**ADDENDUM NO. 1**

**RE: Item #13, March 5, 2025 Letting - NH 0081(114)0, PCN 07DH, Yankton County - ADA,  
Modify Intersection, Signals**

**PLANS:**    Please destroy sheets A1, C2 & L4 and replace with the enclosed sheets, dated 2/19/25. Sheets C2A, C6A-C6F & C11A-C11C were added.

# TEMPORARY SPAN WIRE SIGNAL LAYOUT

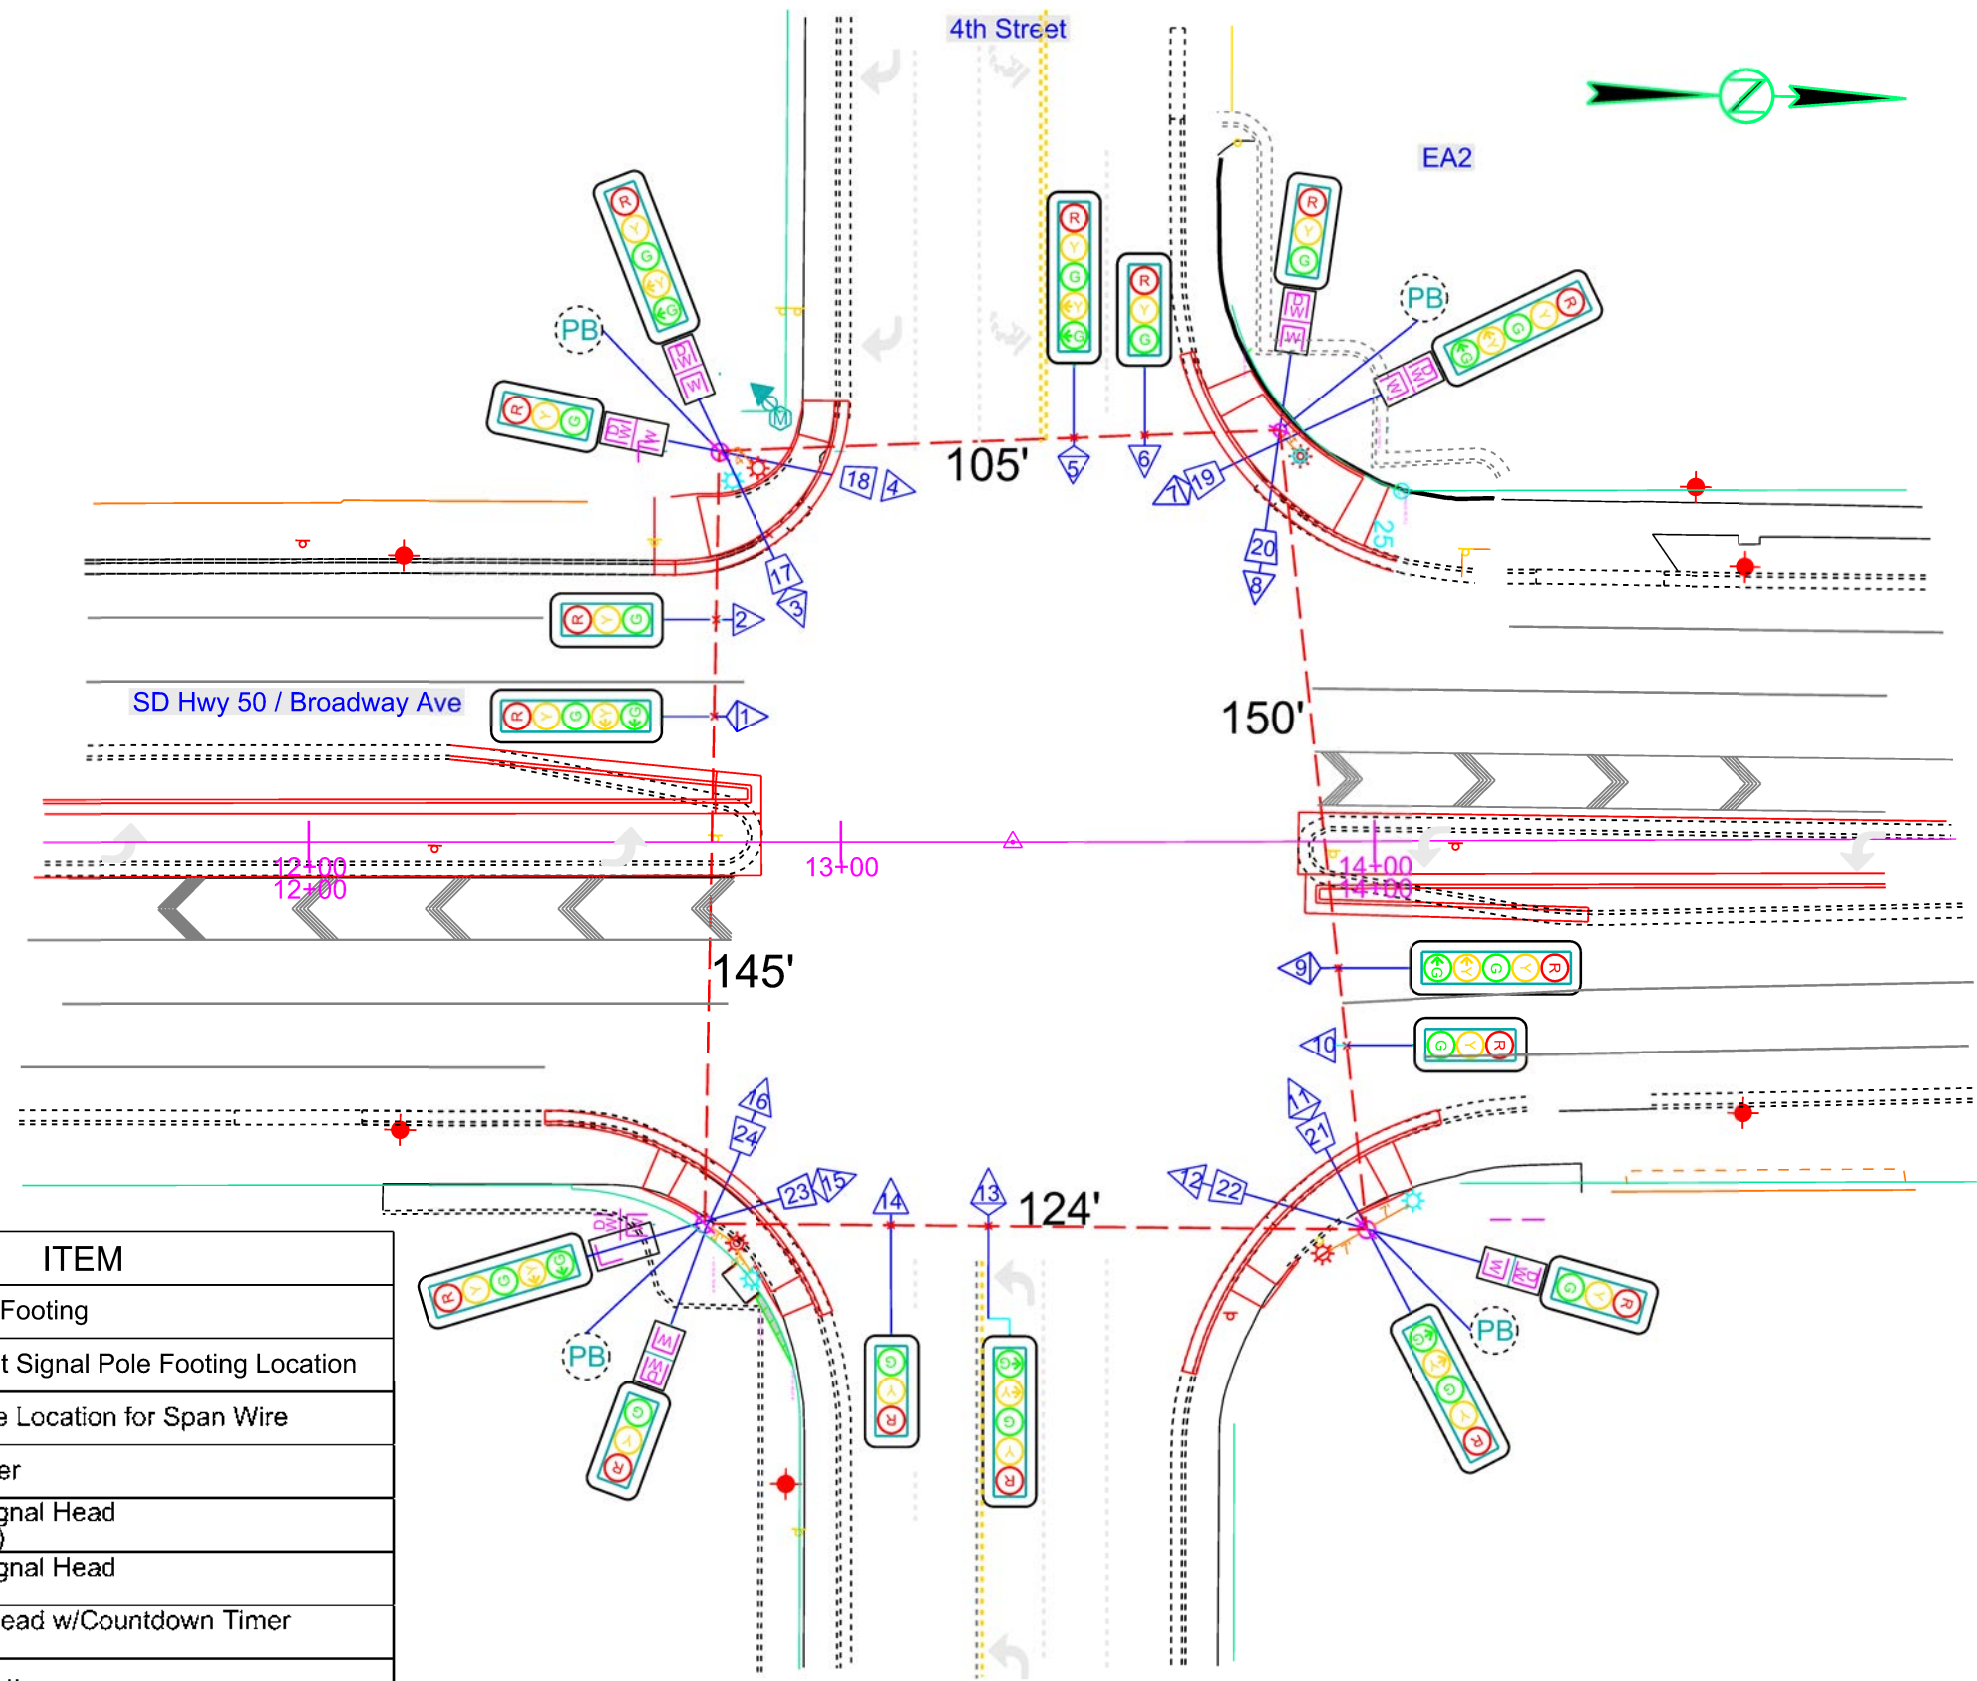
**Sheets C6A-C6F:** TEMPORARY SPAN WIRE SIGNAL LAYOUTS and TRAFFIC SIGNAL HEADS, LUMINAIRES AND SPAN WIRE SYSTEM detail were added.
